SECTION 00 90 01
BIDDING AND CONTRACT REQUIREMENTS
ADDENDUM NUMBER 1

Issued: May 27, 2025

Re: ADDENDUM NUMBER (1) TO THE BIDDING DOCUMENTS FOR

McHenry County College
Engagement Hall
Architect's Project Number: 24-027

1 AV DIAGRAM ENGAGEMENT HALL
12" = 1'-0"

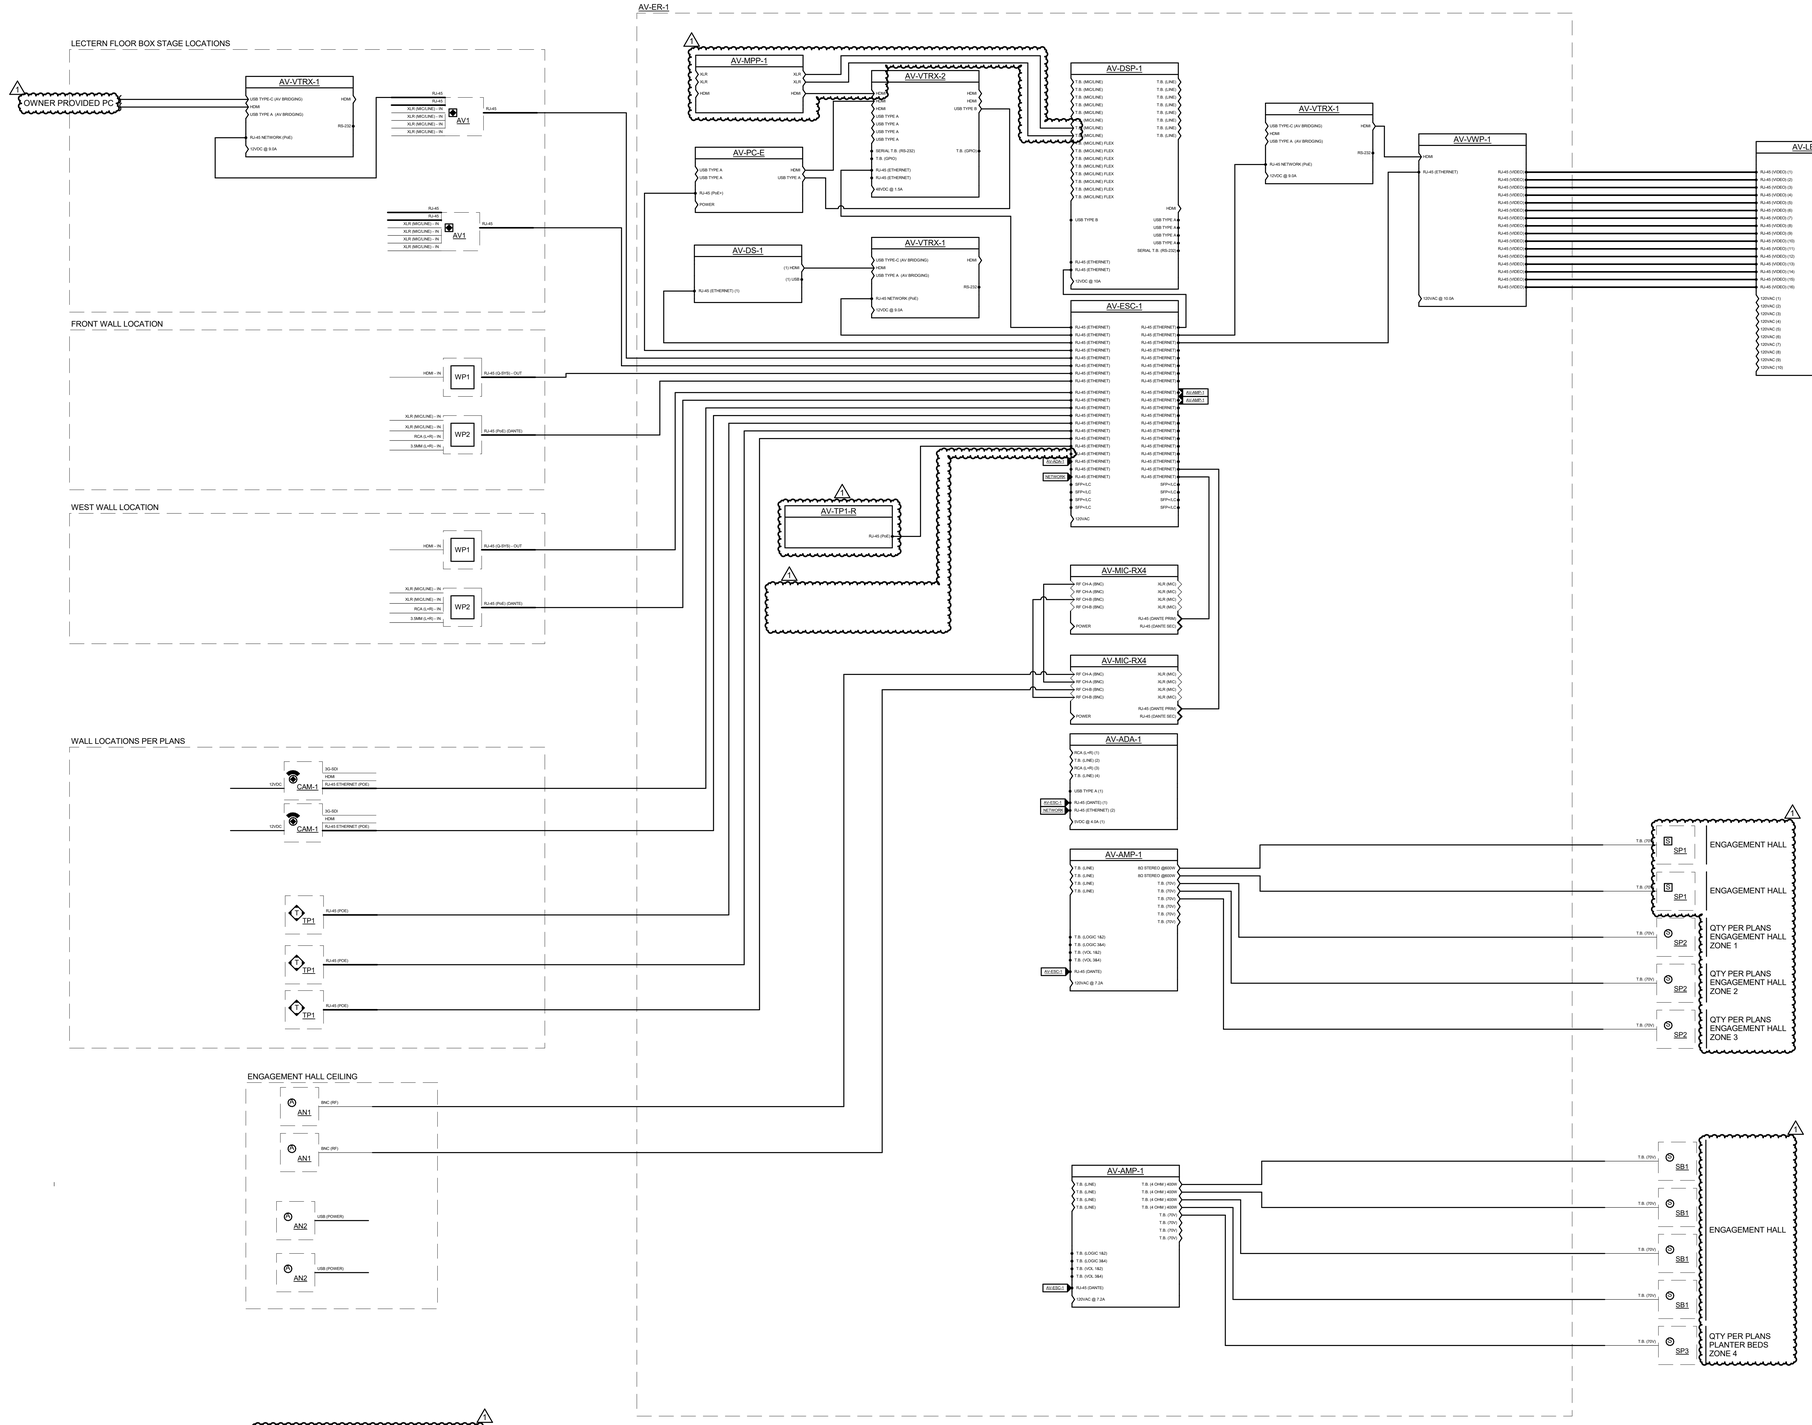
5. T4.00 – TECHNOLOGY DIAGRAMS
   A. **REVISE** Detail #1 title to ENGAGEMENT HALL in lieu of EVENT SPACE
   B. **REVISE** Detail #1AV DIAGRAM – ENGAGEMENT HALL.
